SERVICE BULLETIN

LATERAL MIXER OUTPUT LINK ASSEMBLY, ONE TIME INSPECTION

All Model 600N Helicopters.

Lateral Mixer Output Link Assembly (P/N 600N7636-1, -3).

Figure 1. Attach Point Access**3. IDENTIFICATION**

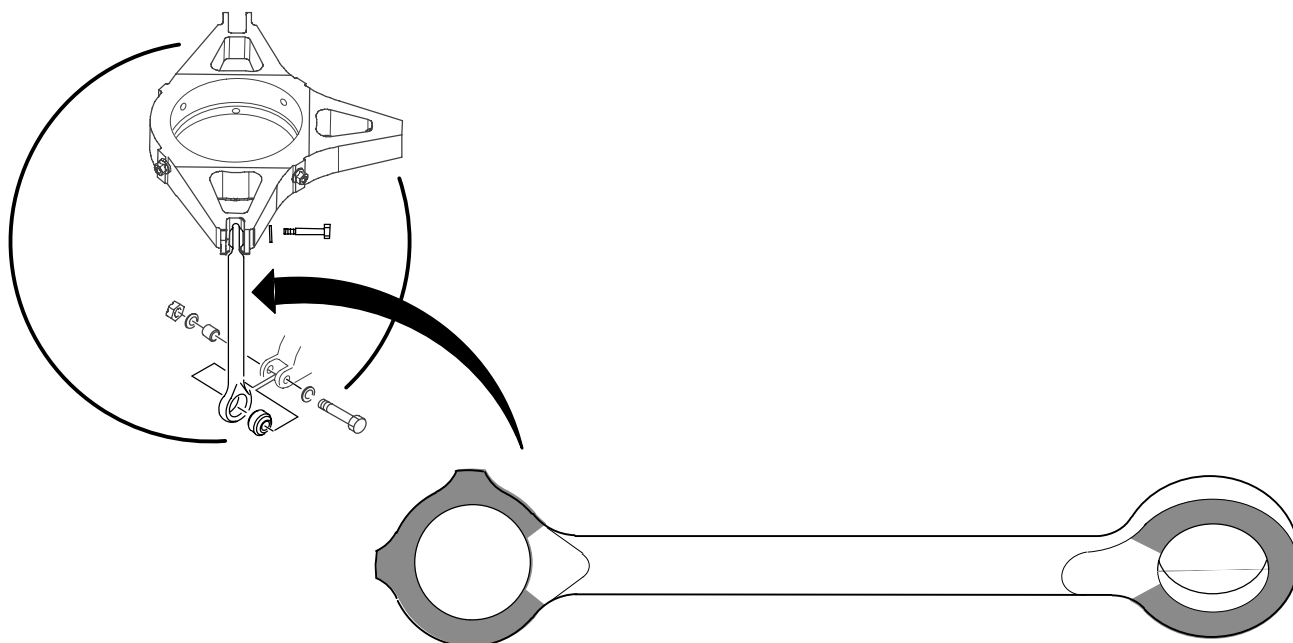
- (2). Using a bright light and a 10x magnifier, inspect link end shaded areas on both sides of the link assembly around bearing bore for indication of cracking. Replace and link assemblies suspected of cracks.
- (3). Reinstall lateral mixer link assembly.

(Ref. Figure 1)

- In the following step, cleaning of the link assembly may be necessary to complete inspection.
 - Eddy current is to be performed by a Level II technician certified by either ASNT-TC-1A or MIL-STD-410 in eddy current and active in eddy current inspection within the last 12 months.
- (2). Perform eddy current inspection of the shaded areas on both sides of the link assembly.
 - (3). Install lateral mixer output link assembly (Ref. CSP-HMI-2, Sec. 62-30-60).
